**Mitigating Systems Performance Index Pilot
Working Group Public Meeting
December 3, 2003**

Appendix H

Containment Integrity Significance Determination Process
(SDP)

Presentation for
ROP Public Meeting

Figure 4.1: LERF-based Significance Determination Process (Phase II)

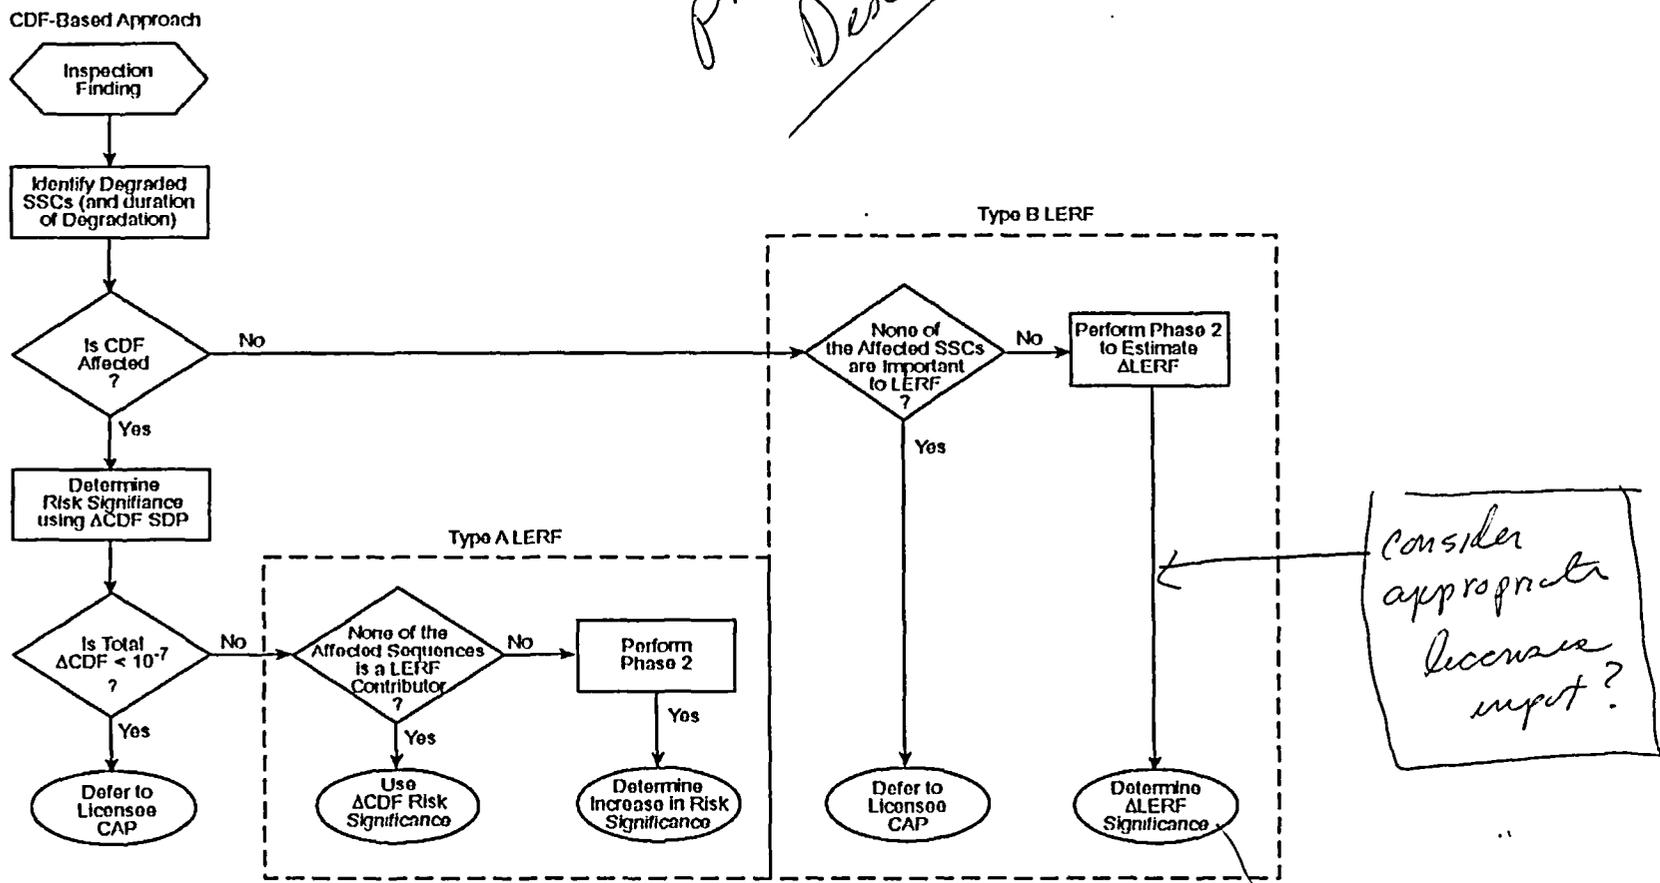
- ❑ **“Logic diagrams (e.g. Figure 4.1 and 5.10 have diamond blocks with negative questions”**

2) Some of the logic diagrams(e.g. Figures 4.1 and 5.1) have diamond blocks with negative questions-This can be confusing.....

Response: Staff will adjust wording to make it clear.

-Staff will consider changes in the forthcoming revision of the appendix.
